MEADOWWOOD ESTATES - PHASE III

LOT 3 - MEADOWWOOD ESTATES SUBDIVISION

SITE PLAN

REVISED: FEBRUARY 24, 2026

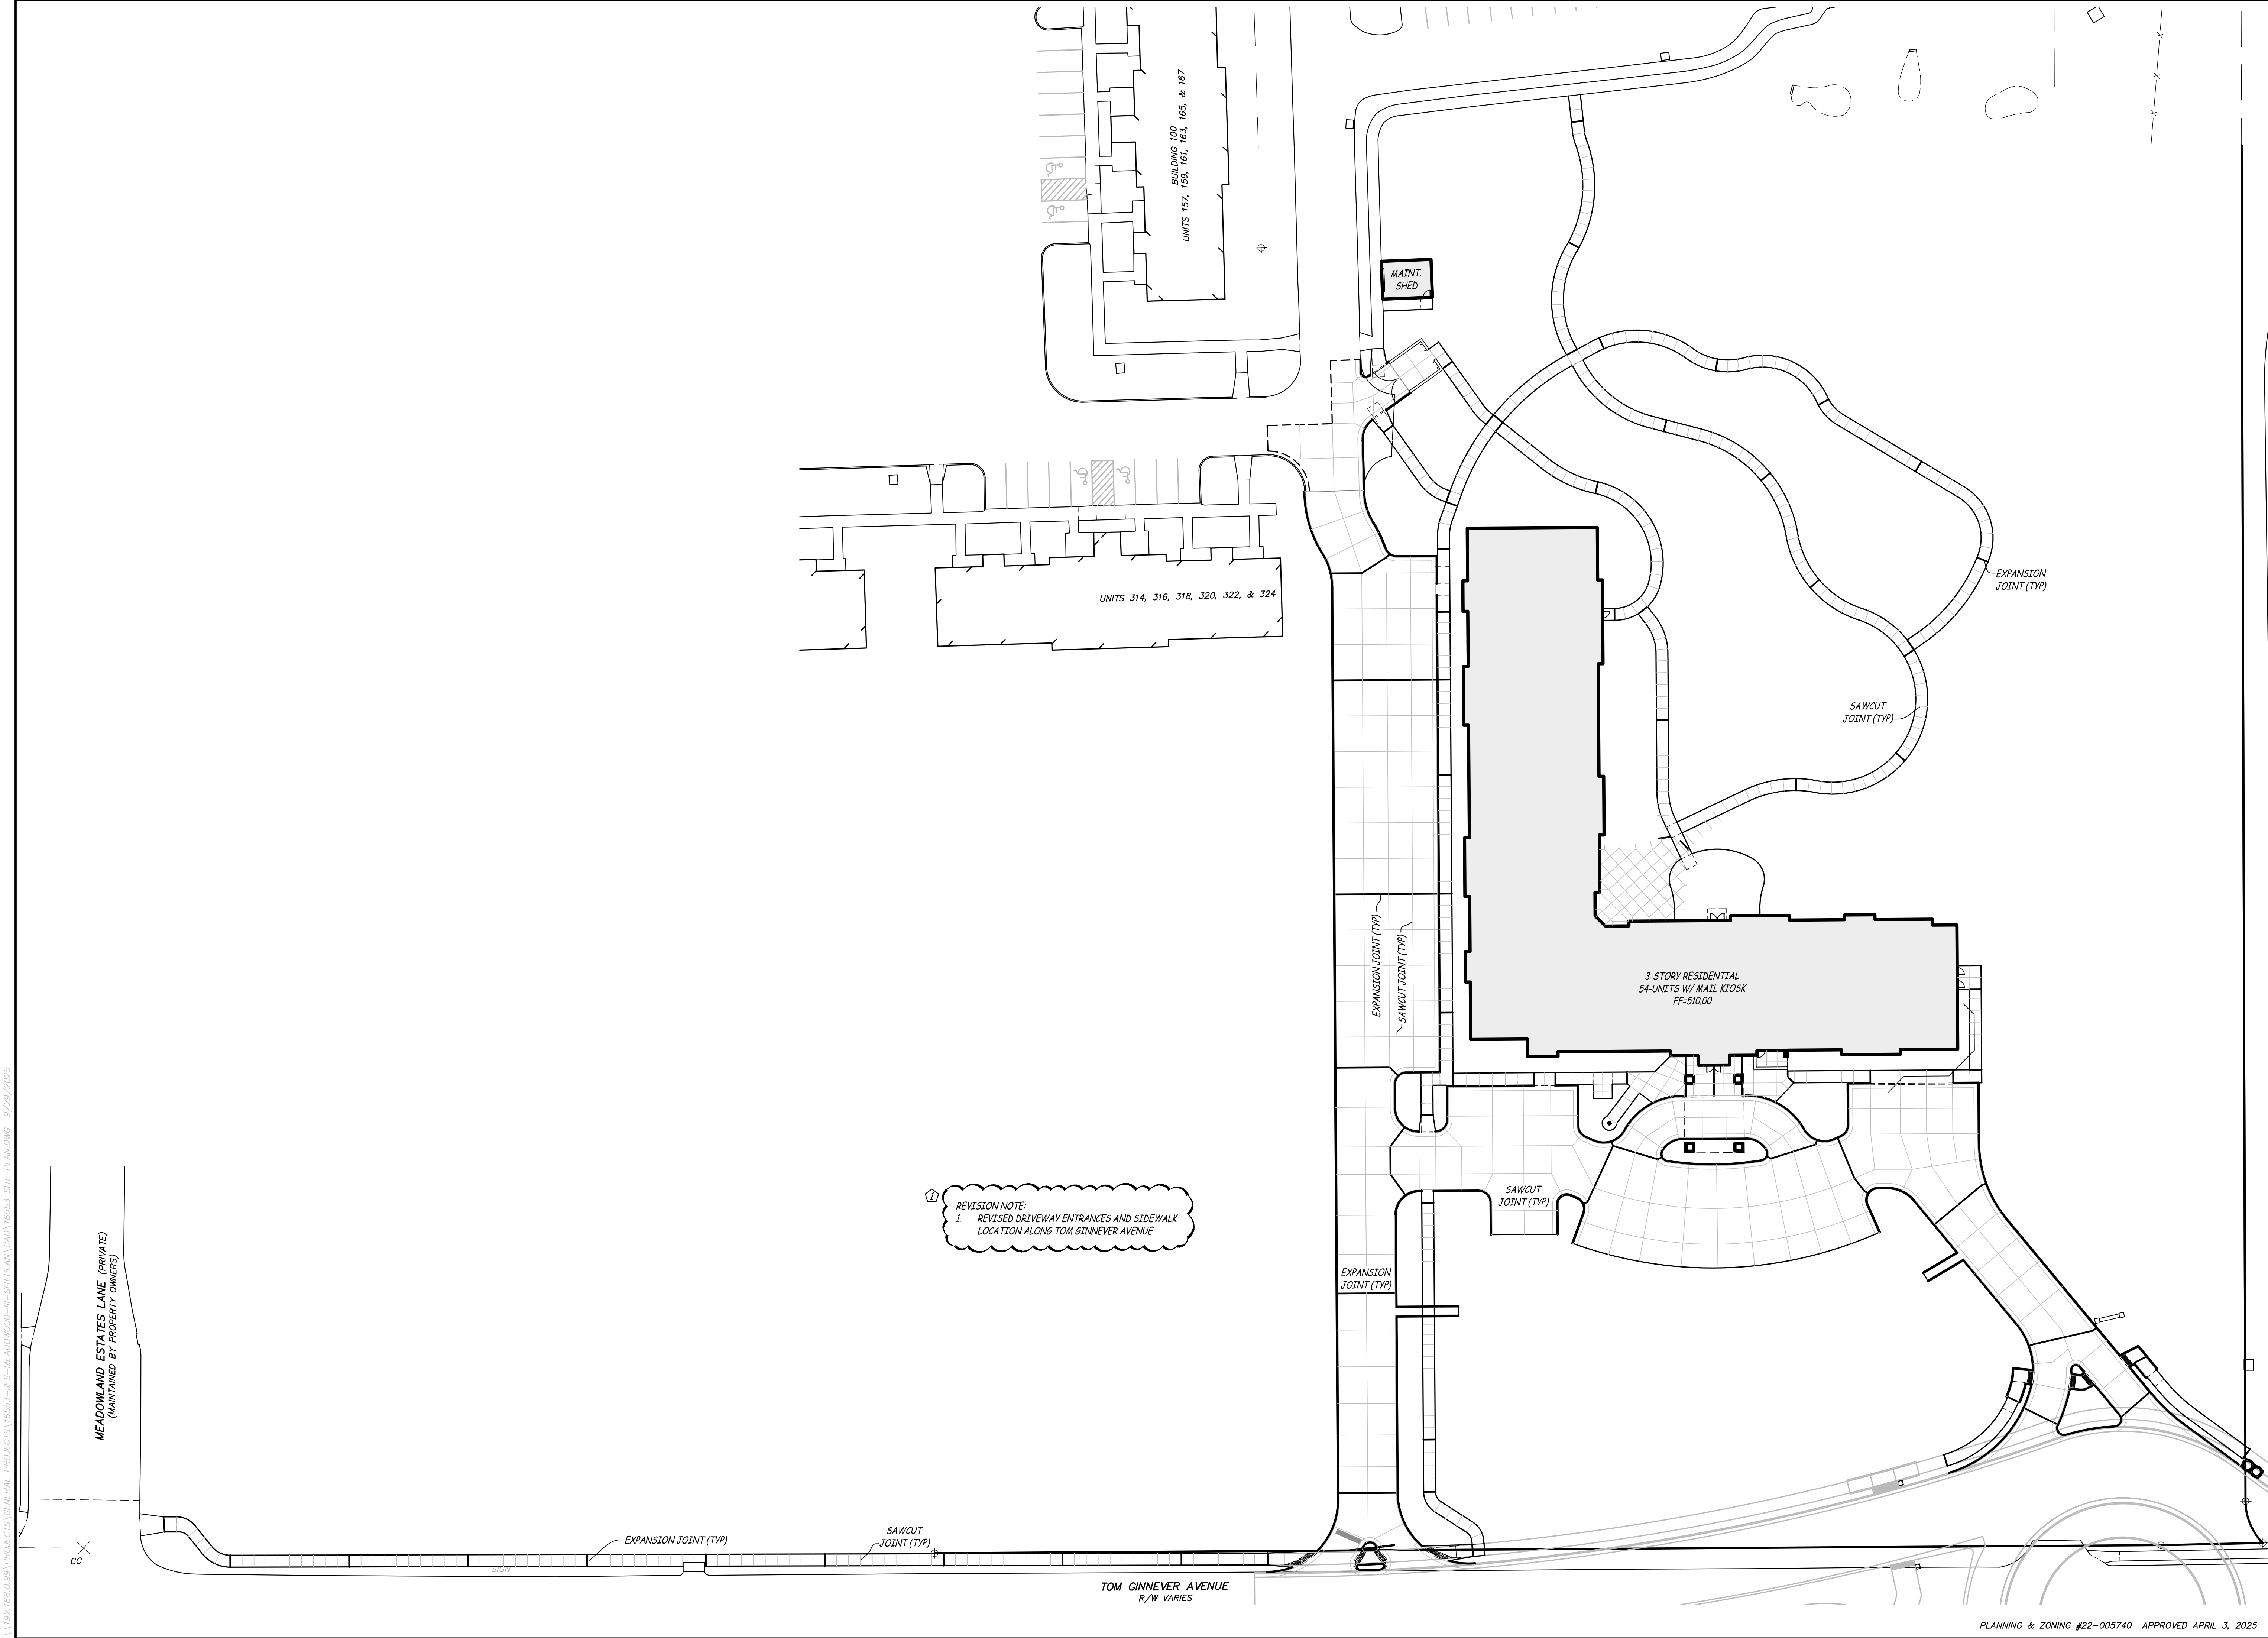
REVISION NOTE:
1. REVISED DRIVEWAY ENTRANCES AND SIDEWALK LOCATION ALONG TOM GINNEVER AVENUE

STORM SEWER PLAN

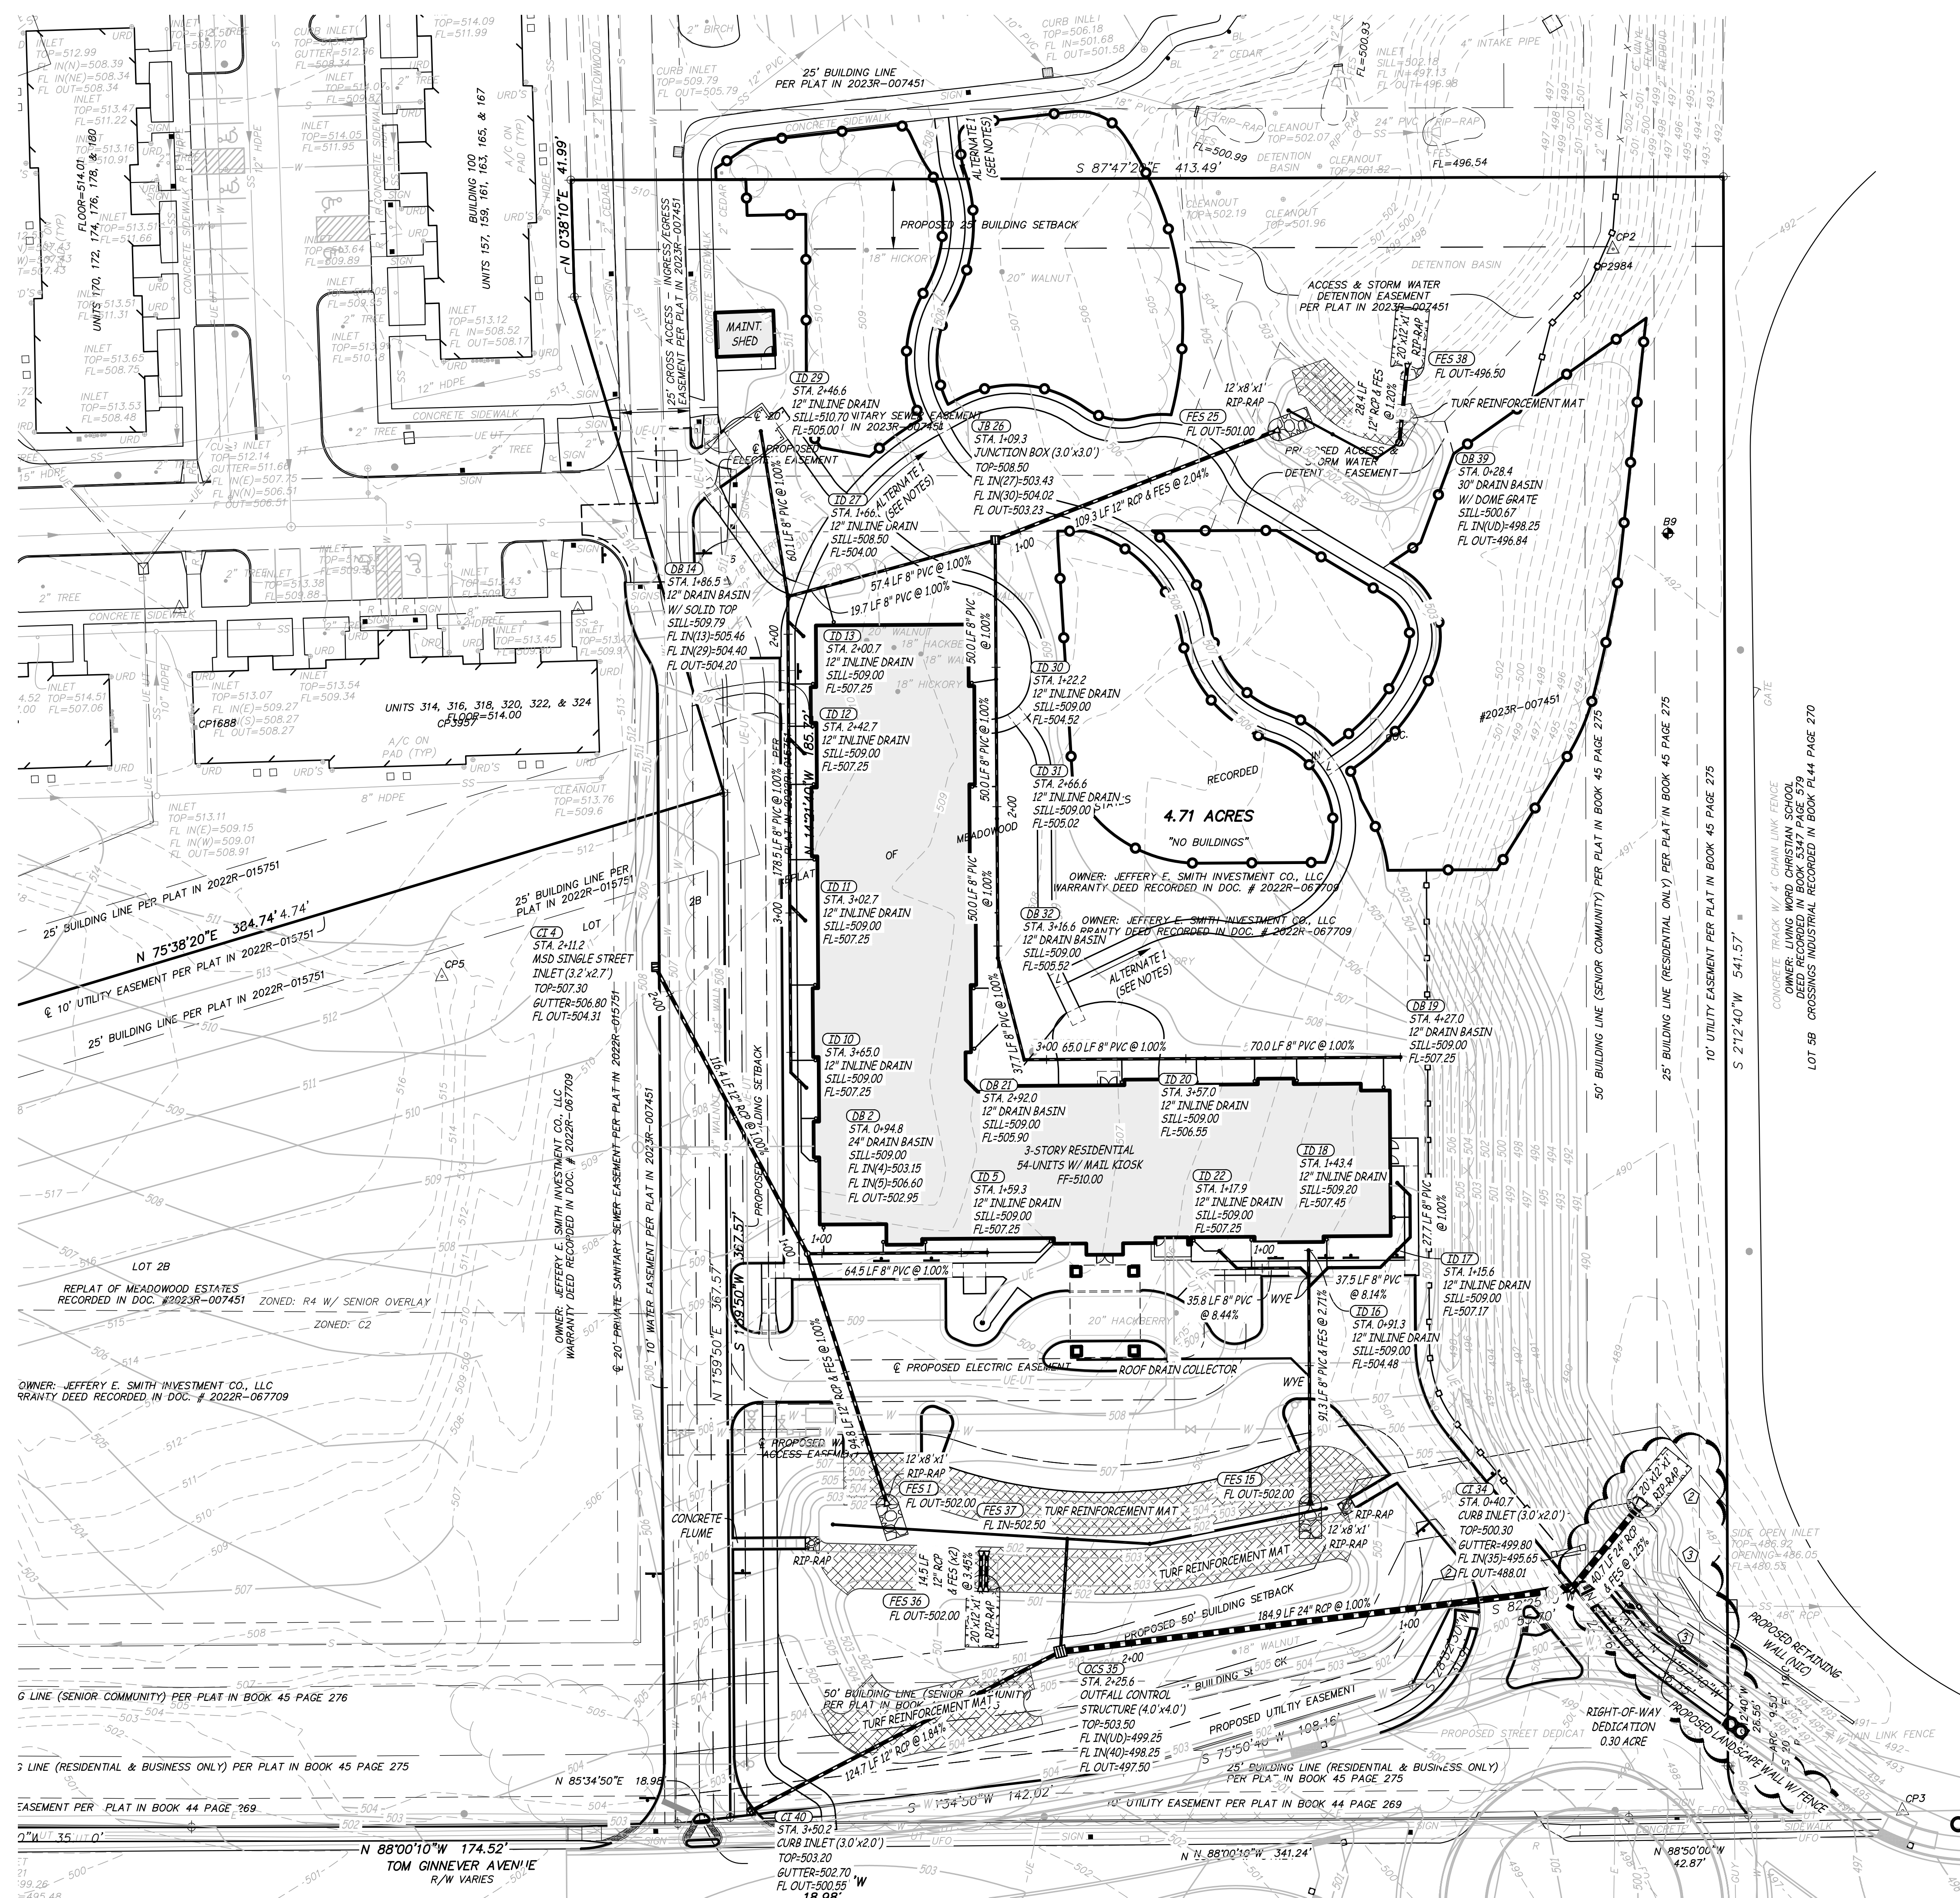
REVISION NOTE:
1. REVISED SITE STORM SEWER LOCATIONS,
TOP ELEVATIONS AND FLOW LINES

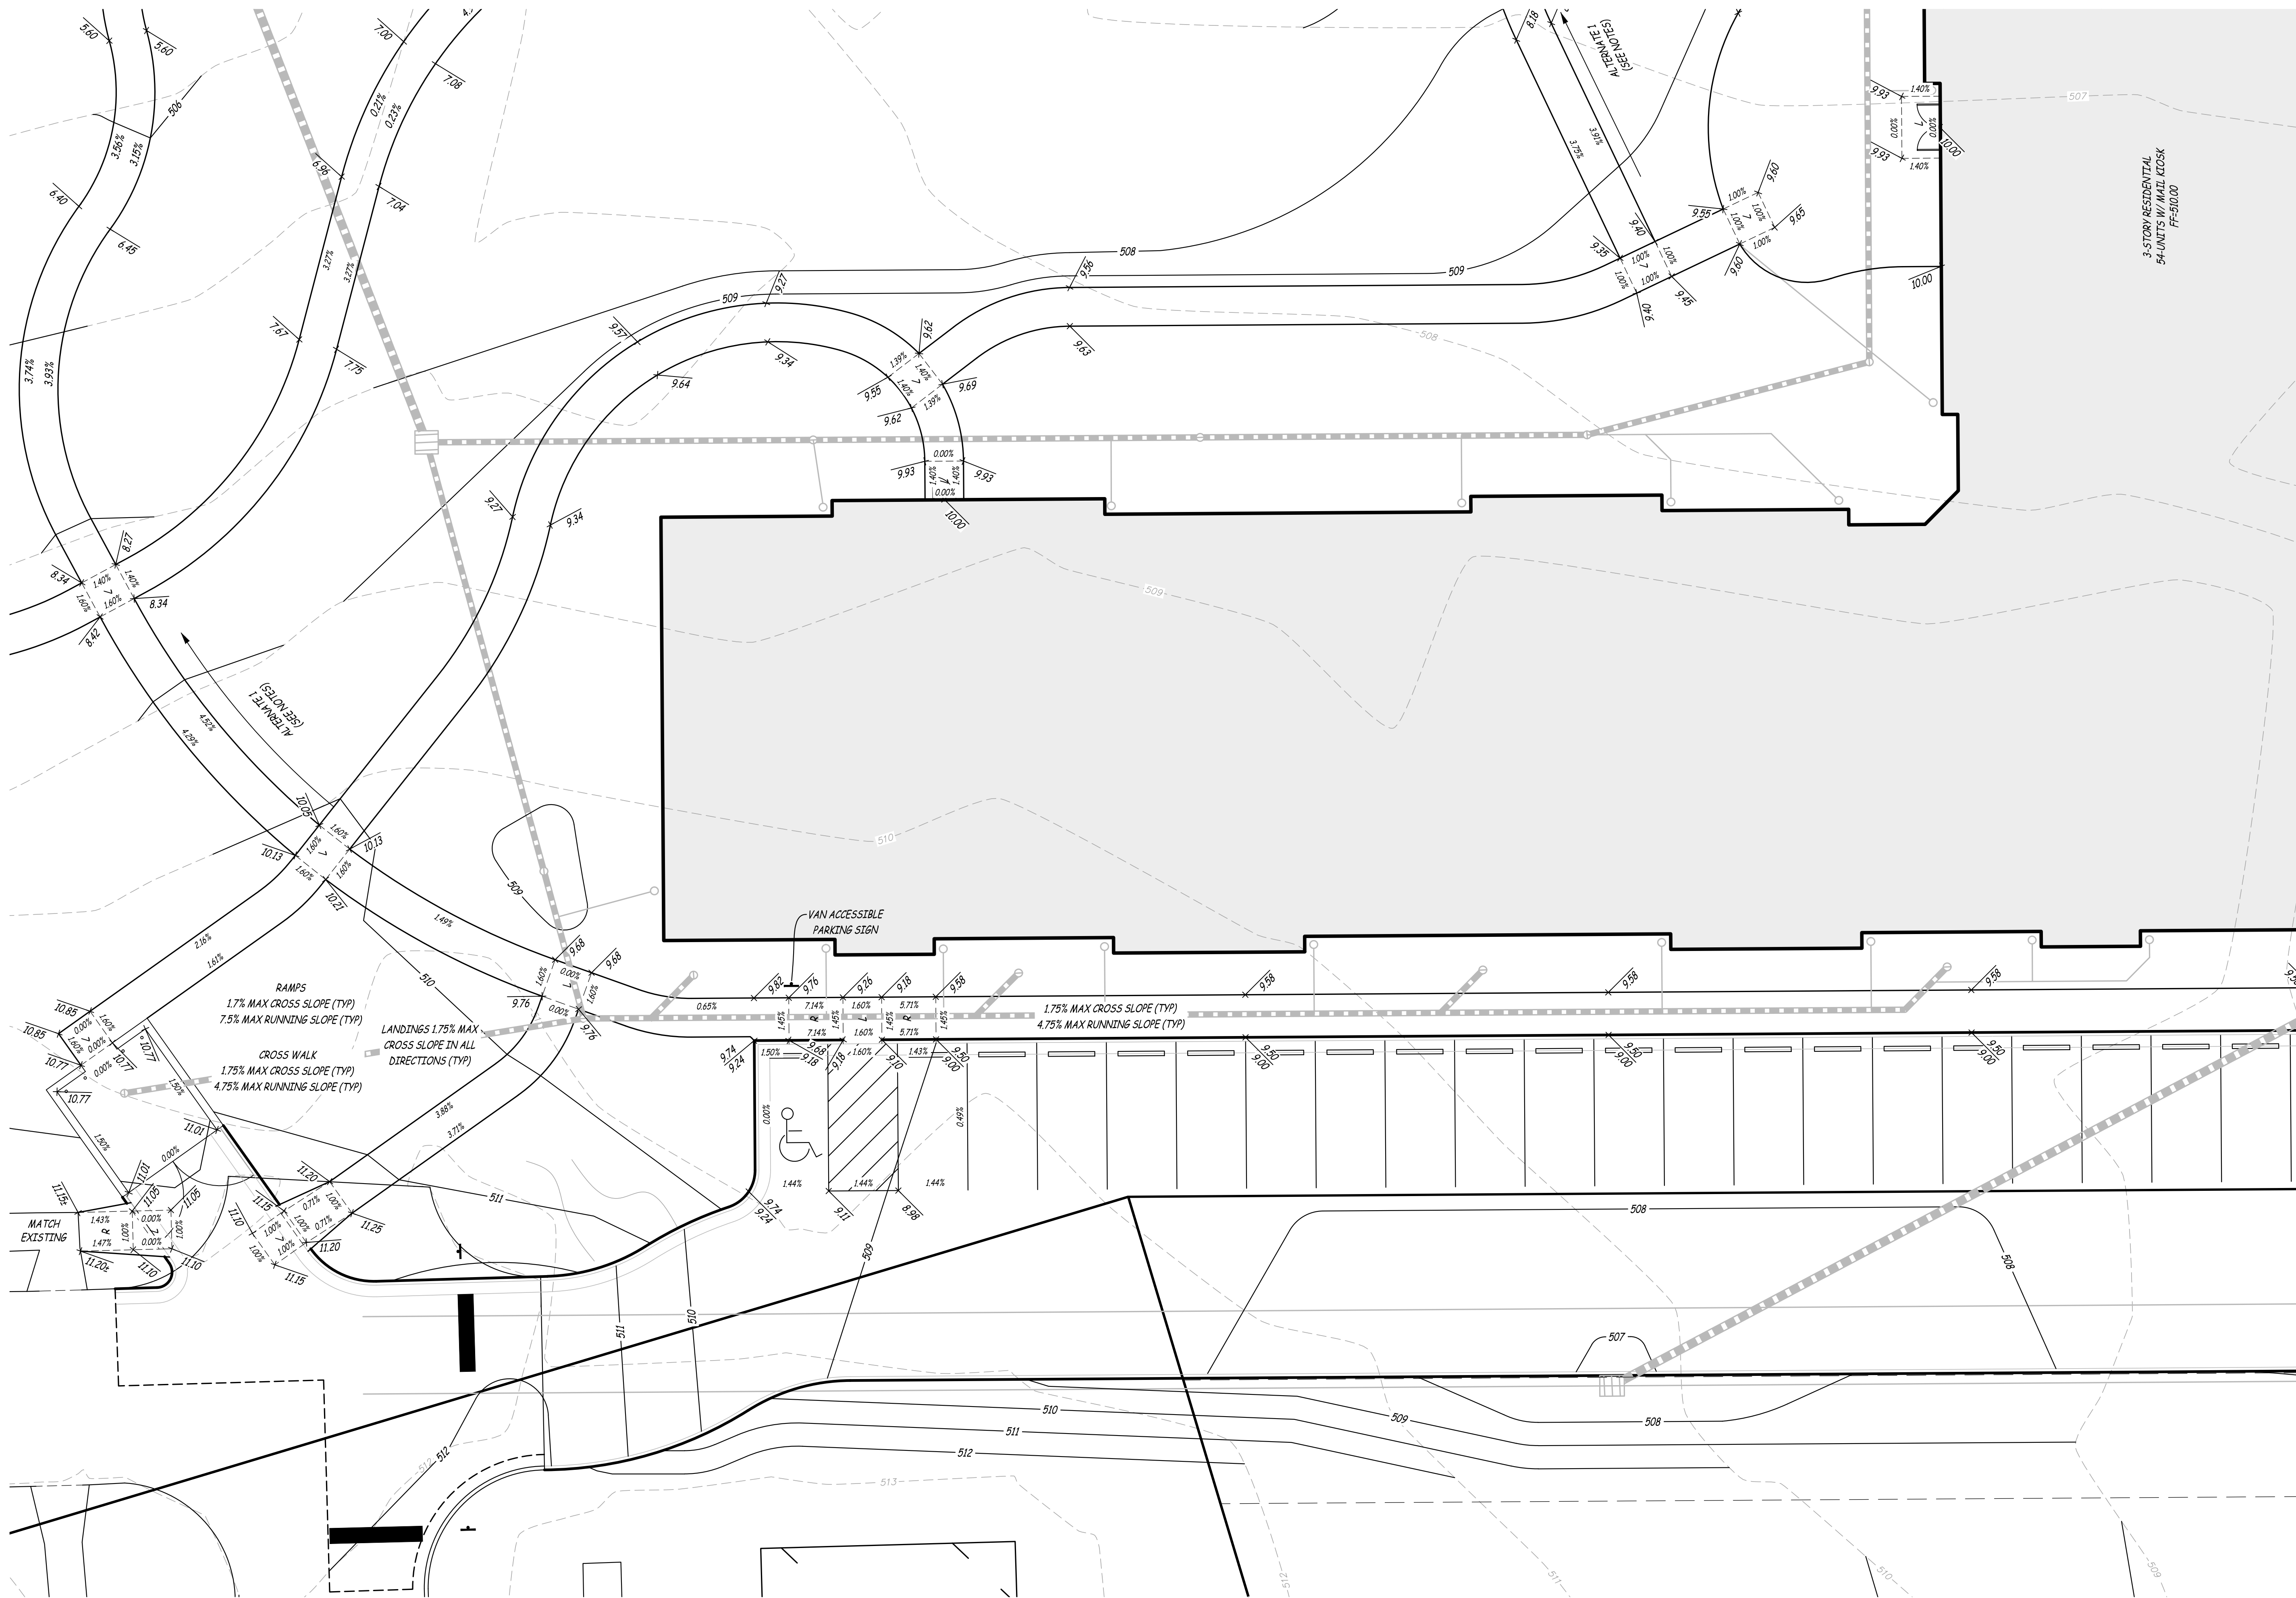
REVISION NOTE:
① 1. REVISED SITE GRADING AND SPOT ELEVATIONS.
② 2. ADDED ADA SLOPES.
